## Marine Safety Center Vapor Control System (VCS) Plan Review Information Sheet (PRIS)

<b>Vessel Name</b>		<b>Shipyard</b>	<b>Jeffboat</b>
<b>Official Number</b>		<b>Hull Number</b>	<b>03-2972 &amp; 03-2977</b>

### LIQUID TRANSFER RATE VS FACILITY VAPOR CONNECTION PRESSURE

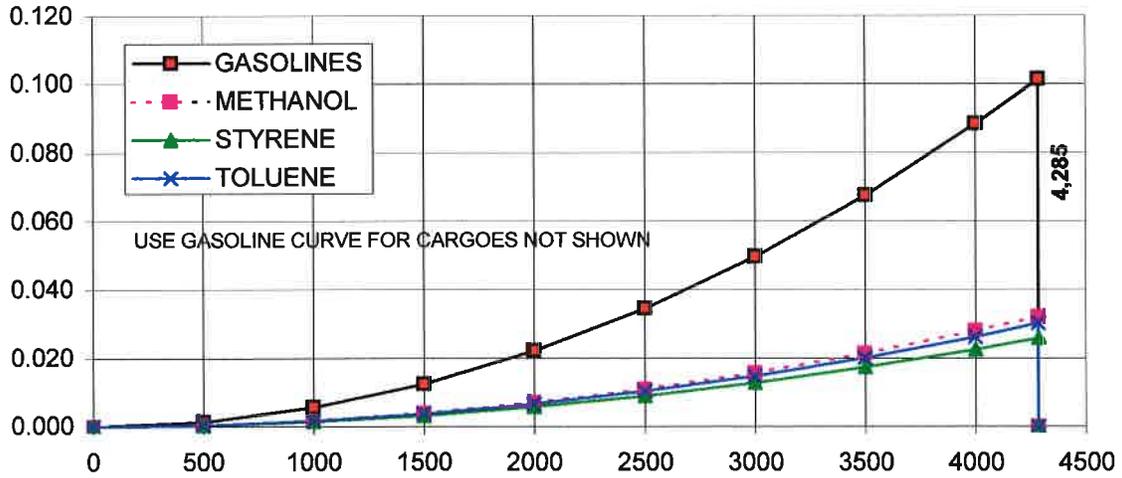
9c. Verify isolation valve at the vapor connection flange is manually operable and designed in a way it is "clearly" open or closed.
